PUBLIC WORKS
Engineering

1. Approve Modification to Standard Detail 366 – Standard Detail for Manhole Steps Location and Invert Details.

STANDARD DETAIL FOR
MANHOLE STEP LOCATION
AND INVERT DETAILS

STANDARD NO. 366

LOCATION OF MANHOLE STEPS

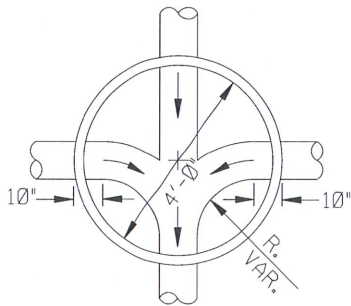
Summary of change: Manholes with 30" cover shall not have steps, unless explicitly directed in writing by City of Tulsa Wastewater Design, or Sewer Operations and Maintenance.

1. MANHOLES WITH 30 INCHES COVERS SHALL NOT HAVE STEPS UNLESS AUTHORIZED IN WRITING BY WASTEWATER DESIGN OR SEWER OPERATIONS AND MAINTENANCE AND APPROVAL BY THE DIRECTOR OF WATER AND SEWER.
